R21BN

DATE: February 27, 2023
TO: Blue Bird Owners
Subject: R21BN: Hydraulic Brake Line Rub on Ford 7.3L

NHTSA Recall Number: 21V-778 School Bus

R21BN: Hydraulic Brake Line Rub on Ford 7.3L

Illustration 1

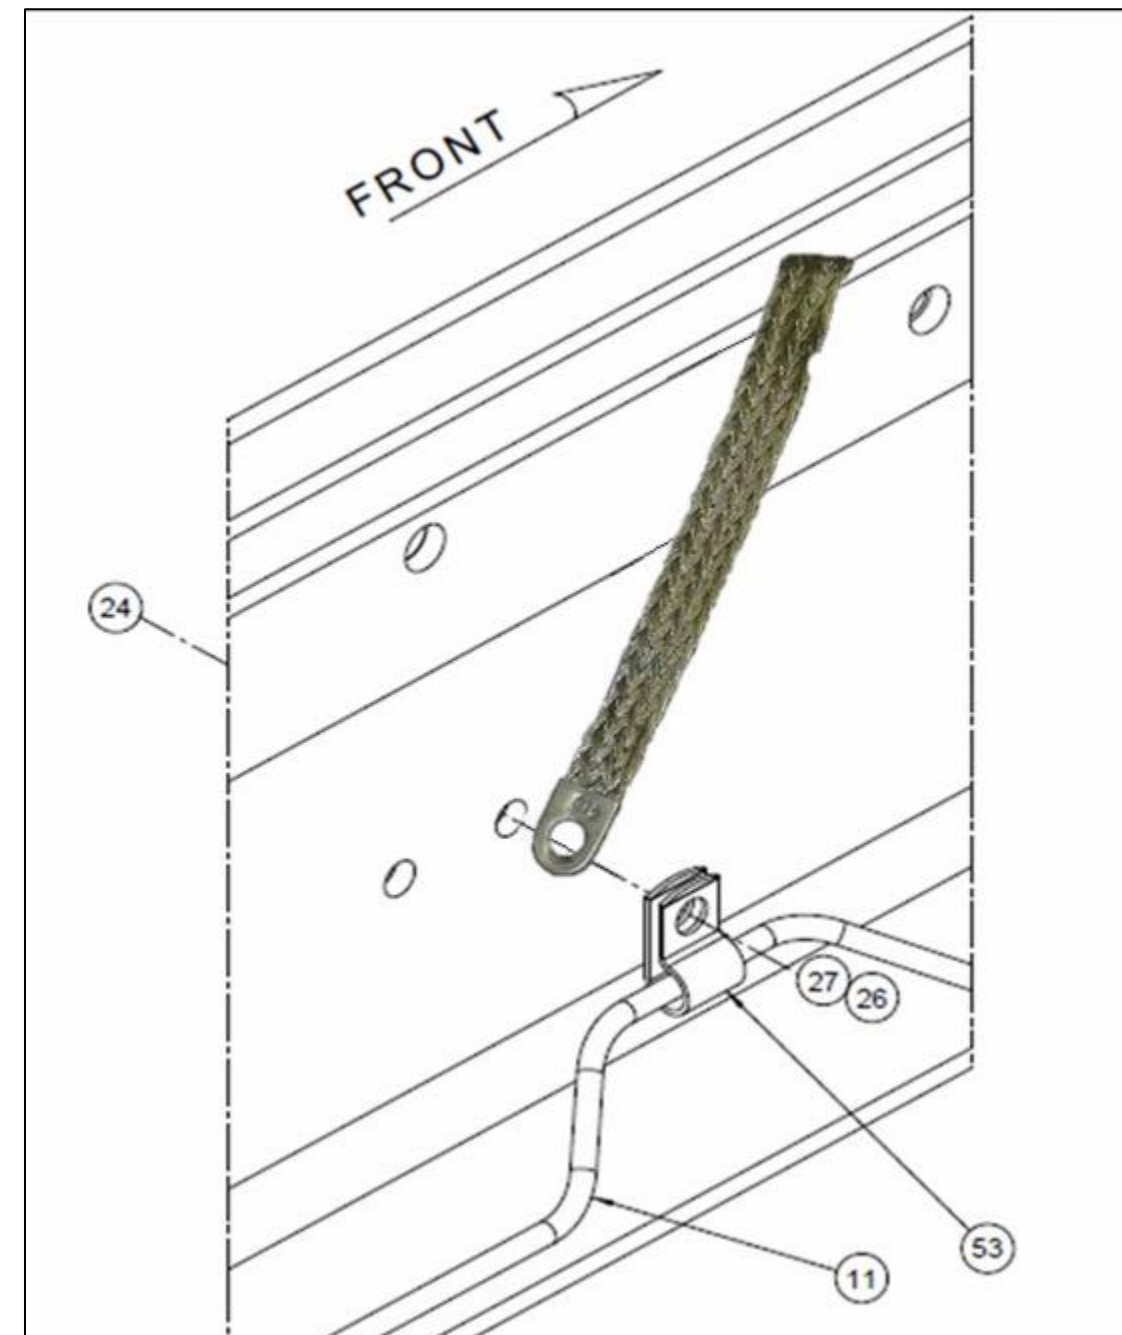
Issue: The left-hand, front hydraulic brake line on certain units may not be properly secured.

- Locate the left-hand front brake line, inside the frame rail, rear of the front motor mount.
- Inspect for a “P” clamp (Item #53) securing the hydraulic brake line to the frame rail at the grounding strap.
 - If the clamp is installed, tight and positioned per Illustration 1, no further action is necessary.
 - If the clamp is missing or incorrectly installed, proceed to the next step.
- Locate the mounting fastener for the engine ground strap. Remove the locking nut securing ground strap to chassis and discard the nut.

Corrective Action: Install P-Clamp over brake line in a downward position, securing the brake line to the frame rail.

- Install P-Clamp 02024370 (Item 53) over brake line, oriented in a downward position, with the flat side of the P-Clamp against the frame rail.
- Insert capscrew and washer (Items 26 & 27) thru the P-Clamp, ground strap and frame rail.

- Install new locknut (Item 24) onto the capscrew on the outside of the frame rail.
- While ensuring the ground strap and P-Clamp are properly positioned, tighten the lock nut and torque to 30 ft-lbs.

*IMPORTANT: The stack of components is critical. Proper sequence is frame, ground strap then P-Clamp
Do not install P-Clamp between frame and ground strap.*
